SITE VISIT

The Rockwood 10 project is a new construction project located in NE Portland, Oregon. The requested site observations on June 16th, 2021 were related to the building enclosure components currently being installed. Areas of specific review included integration of HVAC components and sill flashing on Building E.

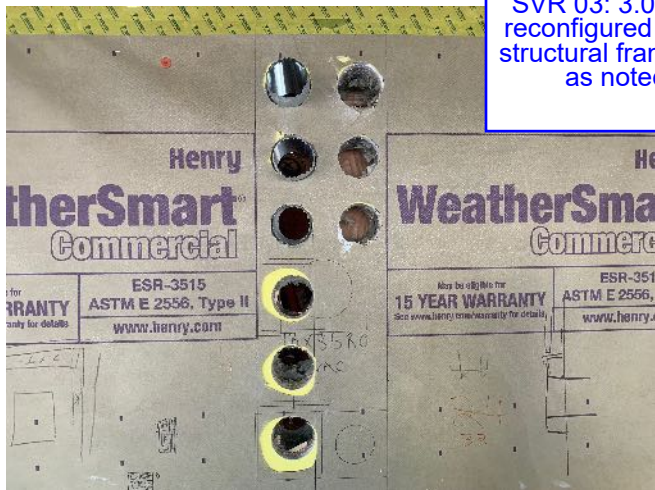
4 .01 Waechter response to RFI 357 called for dryer vents to be arranged with three vents vertically and two rows of vents horizontally at the West wall of Building A at the tuck under parking.

4 .02 Vents will need to be arranged as shown above due to conflicts with framing members in the exterior wall.

Please see responses to SVR 03: 3.06. All exhausts reconfigured to work around structural framing constraints as noted by QEC.

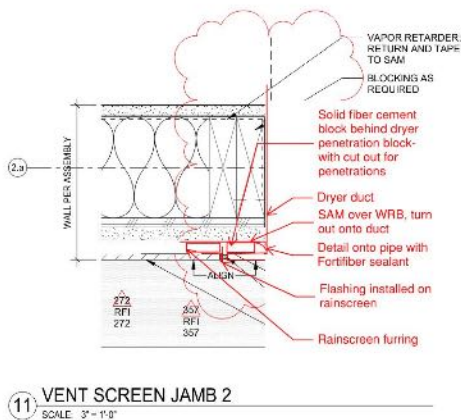
4 .03 This image indicates the installation of the six vertically stacked vents. The three holes to the right will need to be filled in and WRB repaired. Note solid framing in the three holes to the right.
